Draft Environmental Impact Statement  
Lake Ralph Hall Regional Water Supply  
Reservoir Project  
**Volume II**

## **D-1: Evaluation of Hydrologic Modeling**

Please find attached our draft-final report on our evaluation of the hydrologic modeling of the Sulphur River used for the Lake Ralph Hall EIS. This draft addresses your comments to our April 4, 2016 and May 24, 2016 drafts. Pursuant to the review process we have discussed, I submit this draft for your review. If you have no further questions, please forward this draft to the Upper Trinity Regional Water District.

# Evaluation of Hydrologic Modeling in Support of the Lake Ralph Hall Environmental Impact Statement

Figure 2. Hydrographs for each gage showing different levels of flow from different storm events.

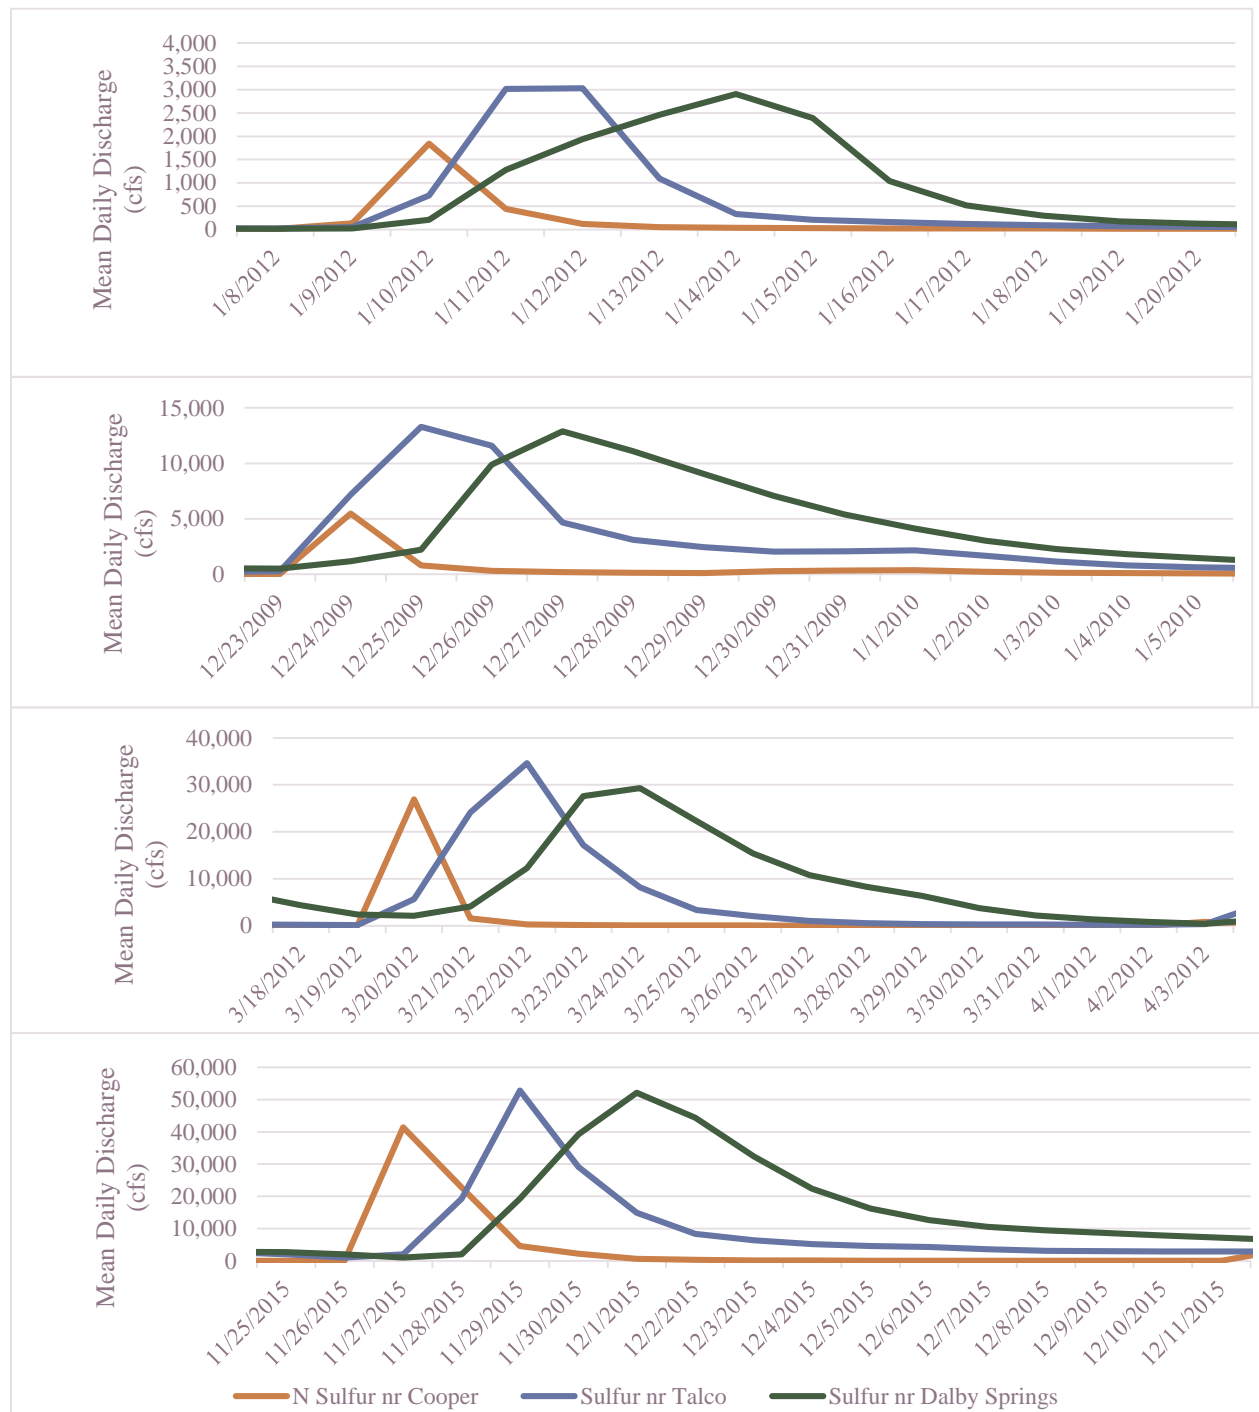
month. Water quality factors may not be accurately represented with a monthly time step, especially in the North Sulphur River. As depicted in Figure 2, the flashy nature of the flows is not captured in a monthly time step, and a small number of large flow events followed by no flow would likely have very different water quality effects than a monthly-averaged flow rate over the entire month. Additional information and recommendations are presented in Section 4 related to specific resources.

Figure 5. Hydrographs from gages for rain event beginning January 8, 2012 for with and without Lake Ralph Hall scenarios.

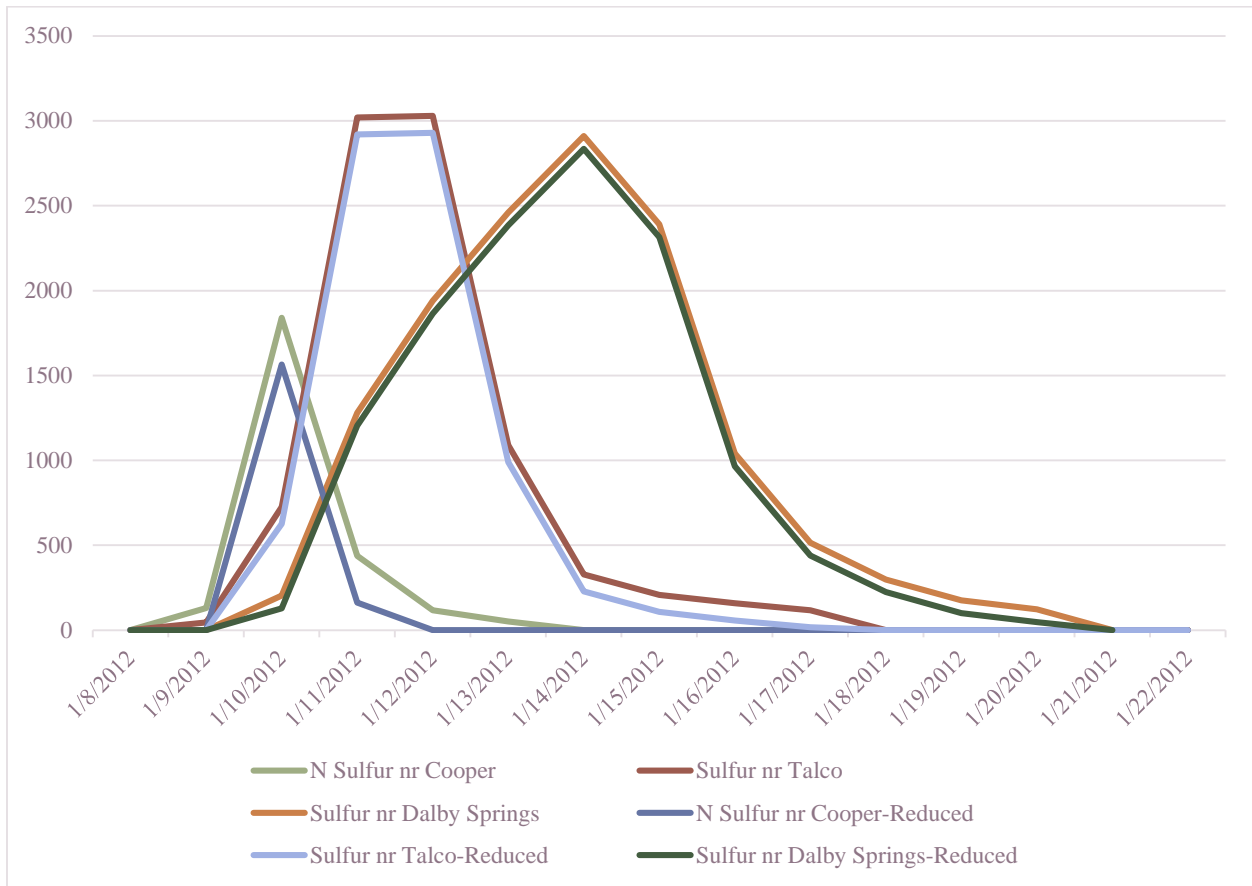
Hydrographs for the January 8, 2012 event are shown in Figure 5 **Error! Reference source not found.** Cross-sections for the Talco and Dalby Springs gages for the without and with Lake Ralph Hall cases are shown in Figure 6 and Figure 7. Cross-Section and water surface of January 8, 2012 rain event at the Dalby Springs Gage for with and without Lake Ralph Hall scenarios., respectively. Figure 8, Figure 9, and Figure 10 are the corollary figures for the December 23, 2009 rain event. Figure 11, Figure 12, and Figure 13 are the corollary figures for the March 9, 2012 rain event. Figure 14, Figure 15, and Figure 16 are the corollary figures for the November 27, 2015 rain event.

The figures show how quickly the impact of Lake Ralph Hall is attenuated at downstream locations. Due to the large difference in contributing drainage area downstream of Cooper gage, a 33% decrease in flow at the Cooper gage due to Lake Ralph Hall has little effect on maximum river stage downstream following a rain event. During larger storms, while the magnitude of the flow decrease is significantly larger due to water going into storage at Lake Ralph Hall, there is still little effect on maximum river stage below the confluence of the North and South Sulphur Rivers. In all four rain events evaluated, the river stage changes at the Talco Gage are small, and become even smaller at downstream locations. The cross-section figures contain both the without Lake Ralph Hall baseline river stage and the with Lake Ralph Hall river stage. The decreases in river stage with Lake Ralph Hall are nearly imperceptible on the cross sections, and the lateral extent of the flow is nearly identical to the without Lake Ralph Hall scenarios. Table 3 shows the changes in river stage at the peak daily flow rates.

Based on the results of the HEC-RAS analysis and the estimates for streamflow reduction due to Lake Ralph Hall, there are no significant floodplain impacts due to the proposed Lake Ralph Hall because the river stage and lateral extent of flows changes very little downstream of the channelized section of the river. As with other resources, additional detail could be obtained by using daily modeling results rather than using the approach applied in this analysis. However, this analysis used conservative assumptions about the amount of water in storage at Lake Ralph Hall at the time of the flow event, so the additional precision gained through daily modeling will not yield differing hydrology results.
